Subject: Glen Lennox Development Agreement
Minor Modification Request

This letter is to request the Town's approval of two Minor Modifications to the Glen Lennox Development Agreement. We would like to increase the maximum allowable ground floor height for Blocks 4 and 9B as further outlined below. Please note that with this modification, the proposed building remains compliant with the approved total allowable building height and allowable upper floor heights per the Glen Lennox Development Agreement and the Major Modification to the Glen Lennox Development Agreement recorded as Deed Book 6767, Page 1256-1261 in the Orange County Registry. This request serves purely to mitigate the impact of grade changes on the ground floor of the proposed buildings.

EXHIBIT A

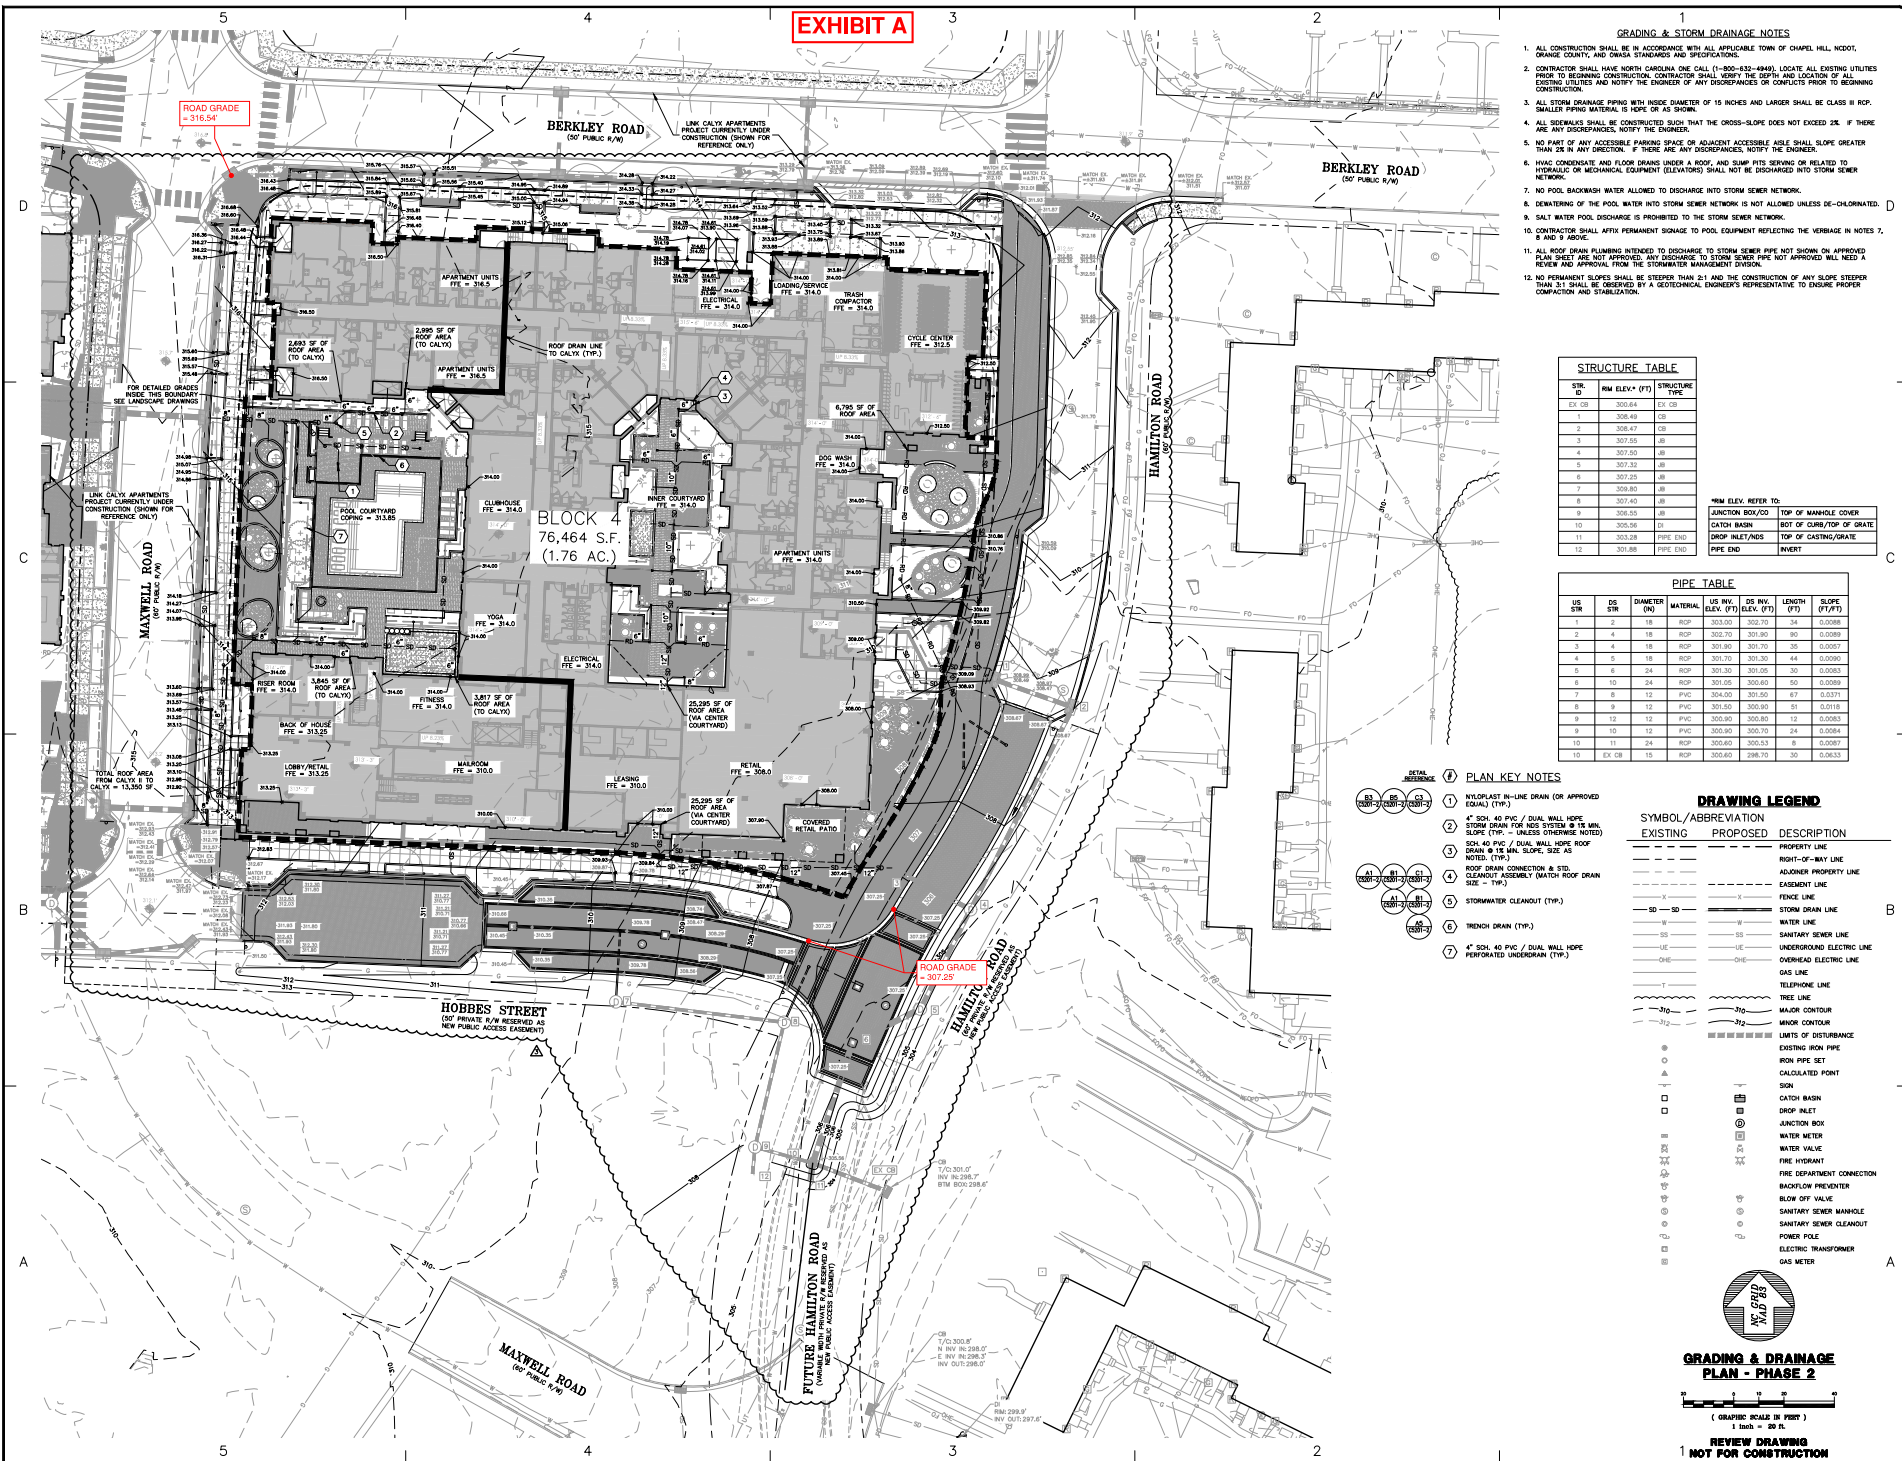
1. We request an increase in the maximum allowable residential and non-residential ground floor height, so that the maximum allowable ground floor height for both uses is twenty (20) feet for Block 4.

- The building is designed so that the ground floor height varies with the adjacent road grades to maintain the same floor level for all upper floors. To maintain positive drainage away from the building, the finished floor elevation (FFE) on the northwest corner of the building was set at 316'-6" and the FFE on the southeast corner of the building was set at 308'-0". The proposed ground floor height at the northwest corner of the building is 10'-8", which is within the allowable residential ground floor range. However, to keep the upper floors on the same level, the proposed ground floor height at the southeast corner of the building needed to be 19'-2" ($316'-6" - 308'-0" + 10'-8"$). We would like to increase the maximum allowable ground floor height to twenty (20) feet to allow for this scenario.

- Exhibit A shows the difference in road grades from the northwest corner of the building footprint to the southeast corner of the building footprint. Exhibits B and C show the building elevations and how they relate to the road grades.

1 Elevation - Office East
 1/8" = 1'-0"
 REF: 1/AB201

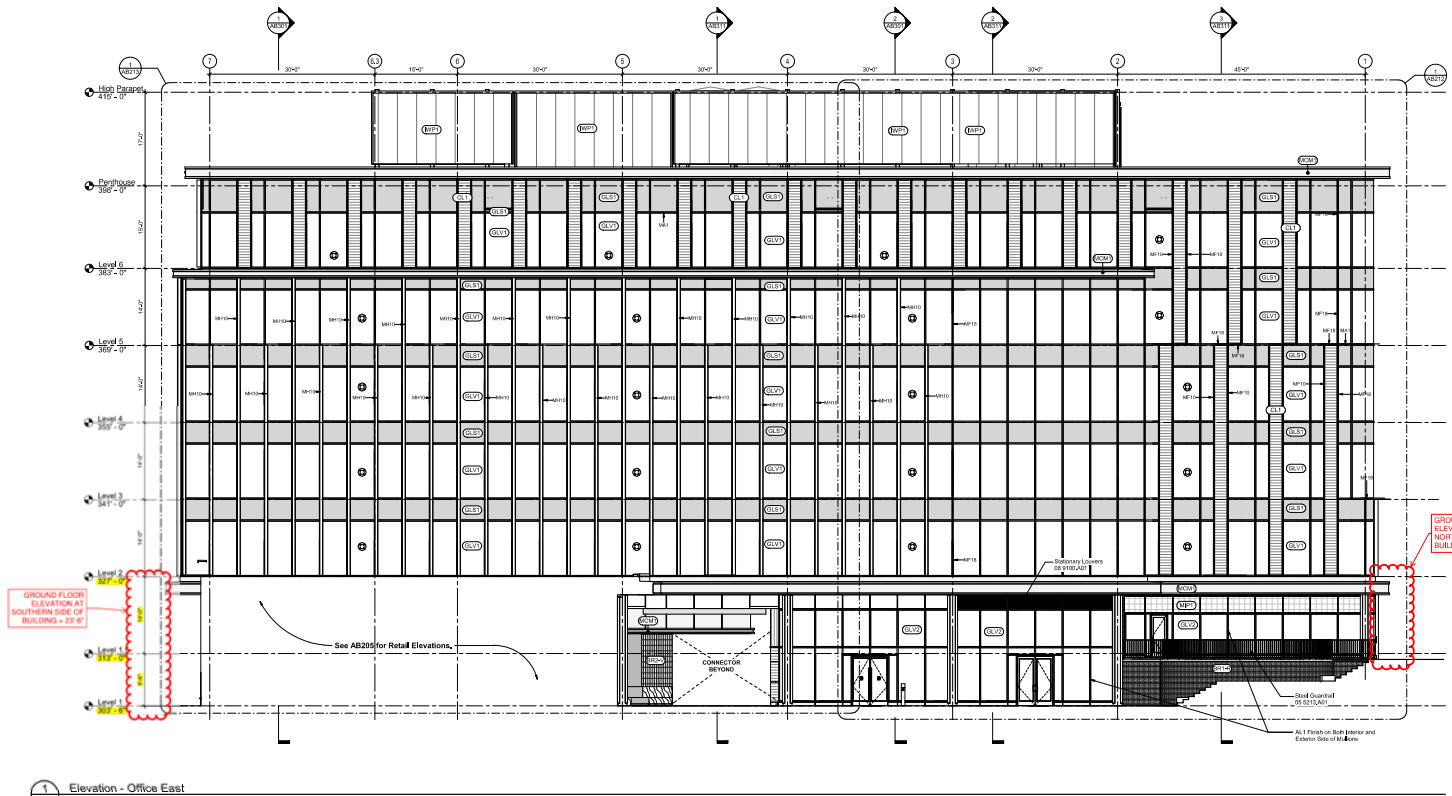
2. We request an increase in the maximum allowable non-residential ground floor height, so that the maximum allowable non-residential ground floor height is twenty-four (24) feet for Block 9B.

- The building is designed so that the ground floor height varies with the adjacent road grades to maintain the same floor level for all upper floors. To maintain positive drainage away from the building, the finished floor elevation (FFE) on the northern side of the building was set at 313'-0" and the FFE on the

southern side of the building was set at 303'-6". The proposed ground floor height at the northern side of the building is 14'-0", which is within the allowable non-residential ground floor range. However, to keep the upper floors on the same level, the proposed ground floor height on the southern side of the building needed to be 23'-6" ($313'-0" - 303'-6" + 14'-0"$). We would like to increase the maximum allowable non-residential ground floor height to twenty-four (24) feet to allow for this scenario.

- Exhibit D shows the difference in road grades from the northern side of the building footprint to the southern side of the building footprint. Exhibits E and F show the building elevations and how they relate to the road grades.
